##### **1958 Agreement – Consideration of draft amendments to existing Regulation**

### **Proposal for Supplement 6 to the 04 series of amendments to Regulation No. 48 (Installation of lighting and light-signalling devices)**

#### **Submitted by the Working Party on Lighting and Light-Signalling (GRE)\***

“Figure 1a: Rear

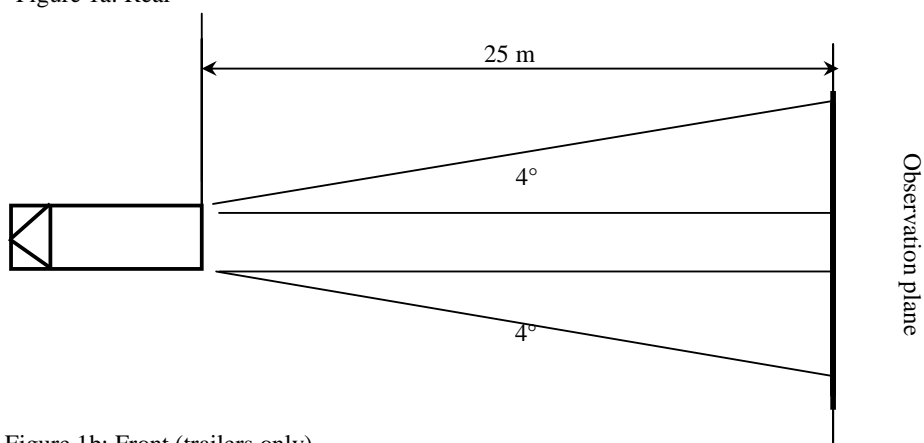
*Annex 11*, amend the figures to read:
